Subject: Duke Energy Corporation Catawba Nuclear Station, Units 1 and 2 Docket Numbers 50-413 and 50-414 Response to Request for Additional Information (RAI) for Proposed Technical Specification Amendment TS 3.4.3 - Reactor Coolant System (RCS) Pressure and Temperature (P/T) Limits TS 3.4.6, RCS Loops - MODE 4 TS 3.4.6, RCS Loops - MODE 5, Loops Filled TS 3.4.10, Pressurizer Safety Valves TS 3.4.11, Pressurizer Safety Valves TS 3.4.11, Pressurizer Power Operated Relief Valves (PORVs) TS 3.4.12, Low Temperature Overpressure Protection (LTOP) System

MARKED-UP TECHNICAL SPECIFICATIONS PAGES FOR CATAWBA

THERMAL STRESS INTENSITY FACTORS AND FLUID METAL TEMPERATURES ASSOCIATED WITH P/T CURVES

Figure 3.4.3-1 (UNIT 1 ONLY) RCS Heatup Limitations

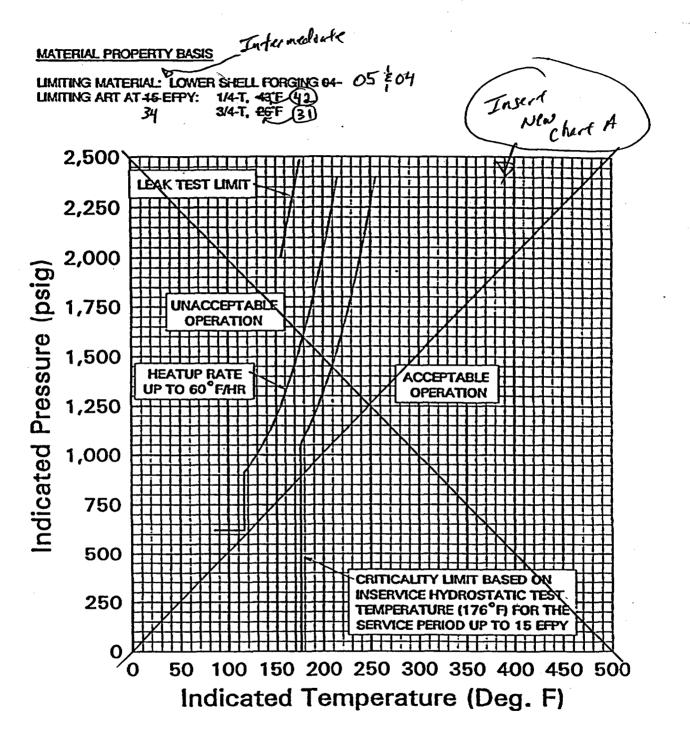
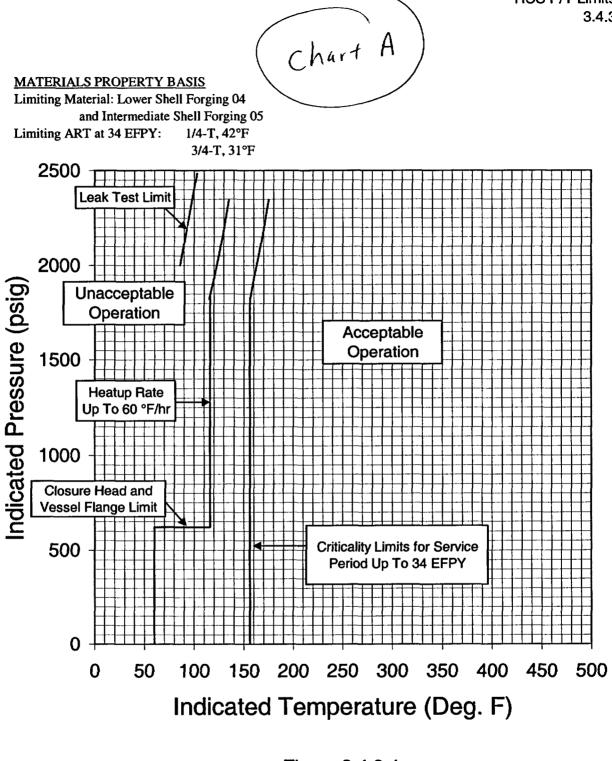
In a telephone call on May 22, 2003, the NRC staff requested two items. The first was for Duke to revise the proposed P/T curves for both units to remove some redundancy in the curves. This will help reduce any areas of potential confusion for personnel implementing the curves. In addition, the criticality limit curve for reactor coolant system heatup on Unit 1 required revision.

This revision ensures that the requirements of 10 CFR 50 Appendix G are accurately shown on the figure.
